## **Access Compliance Report Public Rights-of-Way** (Curb Ramps)

Intersection ID: 3494 Main Street: REAMES RD Cross Street: W W T HARRIS BV Location: NW ADA ID: 34C237323800 Ramp Type: Perp Initial Pass/Fail: Fail **Overall Compliance: No Severity Score:** 22.5

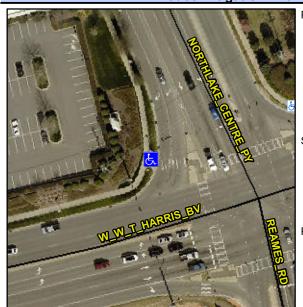
Possible Solutions:	Compli	ance	Description
Remove & Replace Entire Ramp.	N/A	Ram	p Length (in)
·	No	Ram	p Width (in)
	N/A	Flare	Type LT
	N/A	Flare	Slope LT (%)
	N/A	Flare	Traversable LT
	N/A	Land	ing Length (in)
Surveyor Notes:	N/A	Land	ing Width (in)
N/A	N/A	Land	ing Slope (%)
	N/A	Land	ing X Slope (%)
	N/A	Land	ing Curb? (Y/N)
	N/A	Share	ed Landing?
PROW/ADA:	N/A	Gutte	er Ponding?
Not Found, R304.5.1, R304.2.2,	N/A	Gutte	er Lip Ht (in)
R304.5.3	N/A	Paint	ed X Walk1?
		X Wa	lk 1 Direction
	N/A	X Wa	ılk 1 Width (in)
		X Wa	ılk 1 Slope (%)
		X Wa	ılk 1 X Slope (%
	N/A	Ram	p inside XWalk1
		Road	Slope (%)

N/A	Landing Length (in)	N/A	N/A	DWS Provided?	N/A
veyor Notes:			N/A	Landing Width (in)	N/A	N/A	DWS Contrast?	N/A
/ <b>A</b>			N/A	Landing Slope (%)	N/A	N/A	DWS Length (in)	N/A
			N/A	Landing X Slope (%)	N/A	N/A	DWS Full Width?	N/A
			N/A	Landing Curb? (Y/N)	N/A	N/A	DWS Offset (in)	N/A
			N/A	Shared Landing?	N/A			
OW/ADA:			N/A	Gutter Ponding?	N/A	N/A	Gutter Slope (%)	N/A
ot Found, R304.5.	1, R304.2.2	<u>)</u>	N/A	Gutter Lip Ht (in)	N/A	N/A	Gutter X Slope (%)	N/A
